ATTACHMENT 1

Detailed WSPA Comments on Specific Sections of the 2nd Draft SIP

Figure 2-1. Washington's Class 1 Areas and IMPROVE Monitoring Network Sites (Ecology, 2021, annotations added)

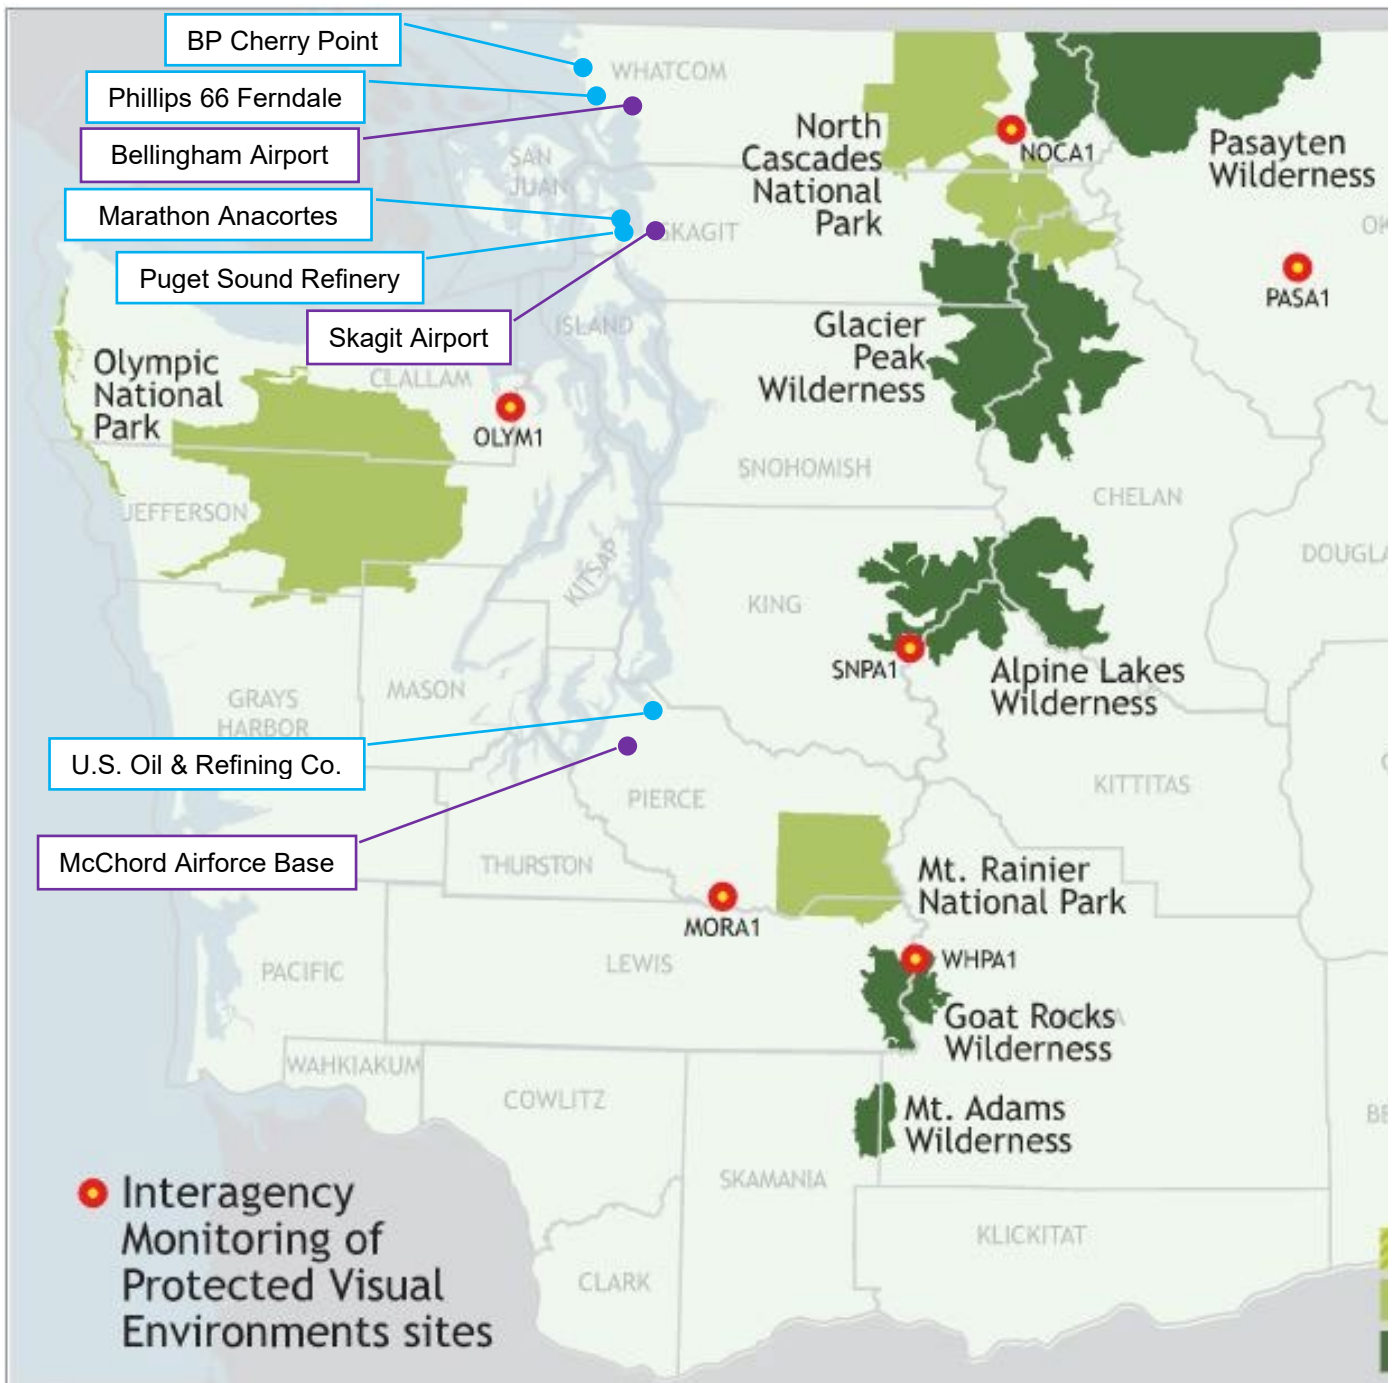
**Map of Washington State Class 1 Areas with Wind Roses**
